**From:** [John Ellis](#)  
**To:** [Cates, David](#)  
**Cc:** [Kalman, Kenneth](#); [Downs, Brittany R.](#)  
**Subject:** [External\_Sender] Re: Questions about raffinate disposal  
**Date:** Wednesday, September 09, 2015 5:03:24 PM  
**Attachments:** [SFC responses to questions from David Cates.docx](#)  
[FIGURE A R5.pdf](#)

SFC responses to questions from David Cates – ODEQ

PROJECT: SEQUOYAH SITE DISPOSAL CELL

TITLE: PROPOSED MATERIAL CELL LOCATION

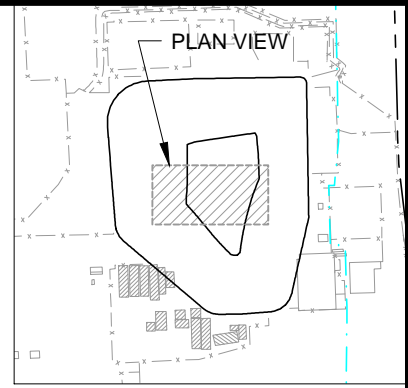
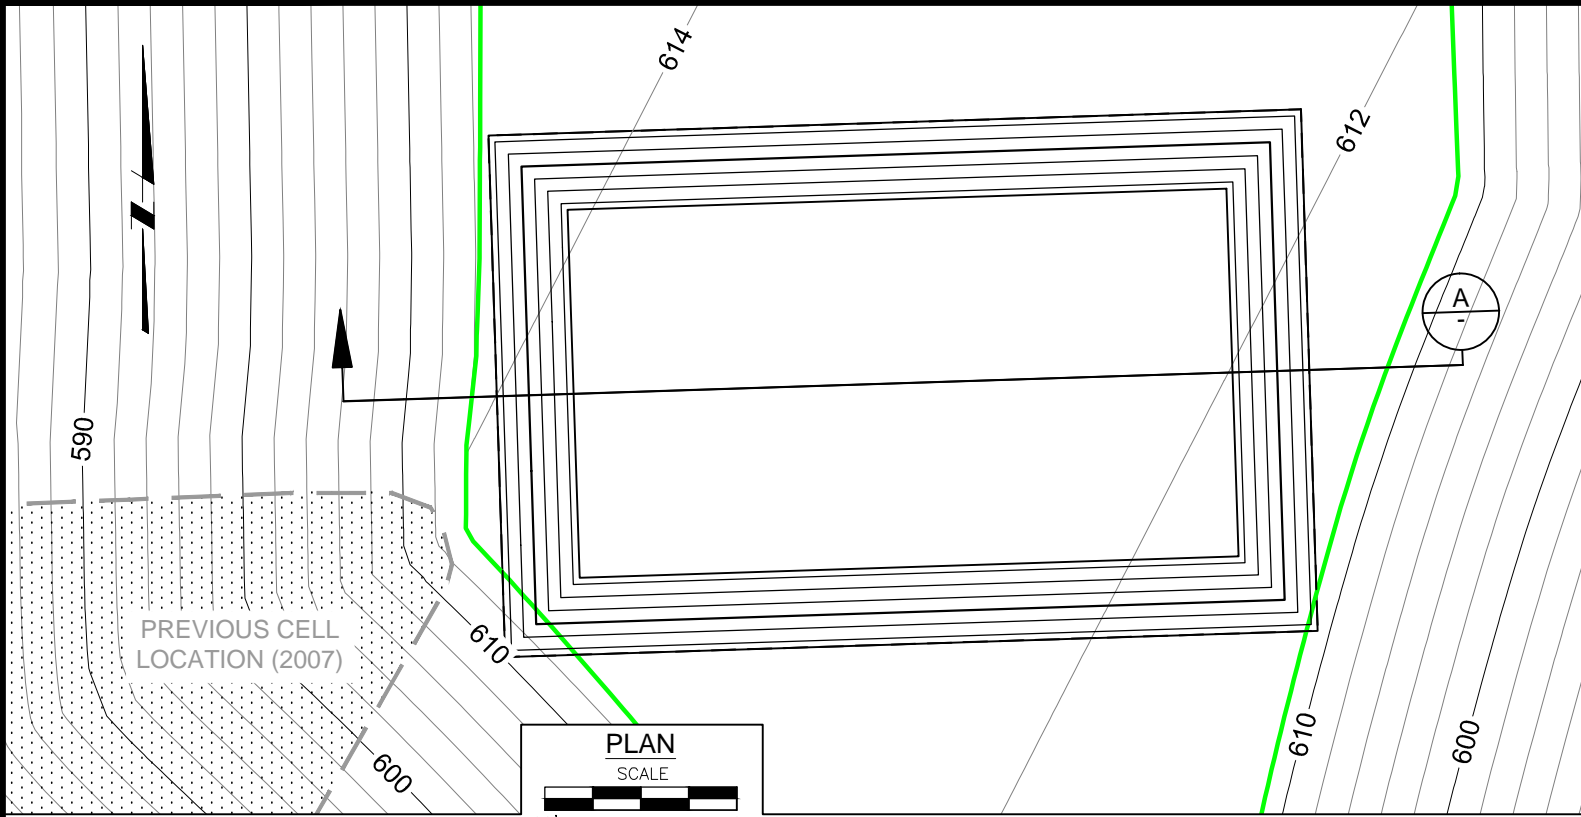
7. How will contaminated groundwater from the interim measures (e.g., French drain systems) be treated once the clarifiers used for chemical precipitation are closed? – use the cation exchange system?

We have a water treatment area that has five tanks, filtration and an ion exchange system. We can use either chemical precipitation or ion exchange to treat the water. Once the volume of water requiring treatment is sufficiently reduced, we can switch to this system.

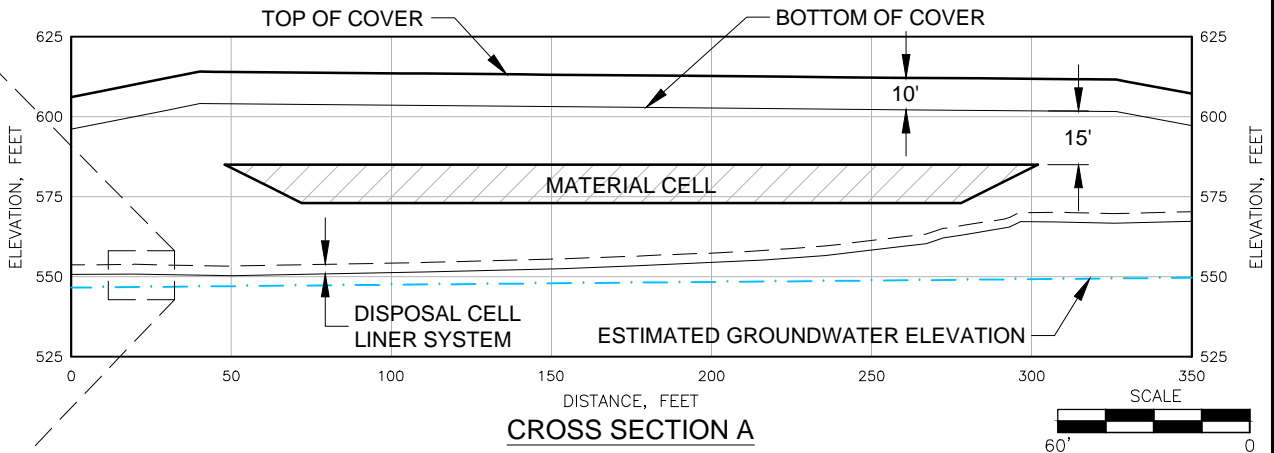
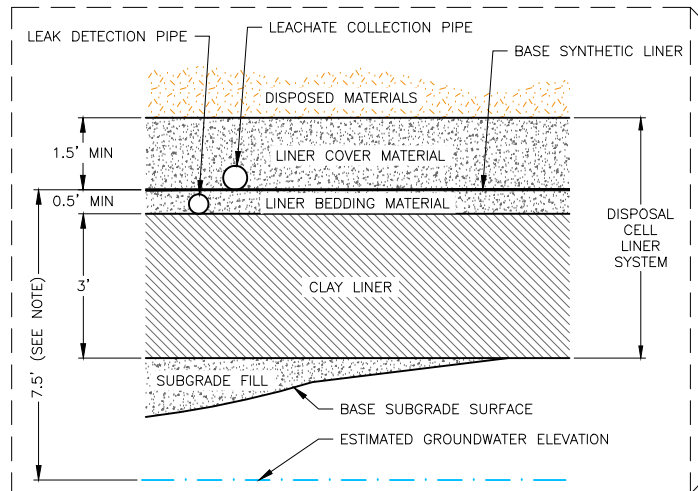
4. Where will the sacks be placed within the cell? Distance to bottom liner? Distance to top of cover?

The sacks will be placed in the north central part of the Phase III portion of the cell. Distance to the bottom HDPE liner will vary from x feet to y feet (the bottom of the Phase III cell base is sloped to the west to assure drainage of leachate to the collection point. The distance from the top of the raffinate bags to the top of the cell cover will be a minimum of 23 feet, which is the thickness analyzed in the Reclamation Plan. The attached drawing (Figure A R5) depicts the approximate location of the raffinate bags, both in plan and elevation views.
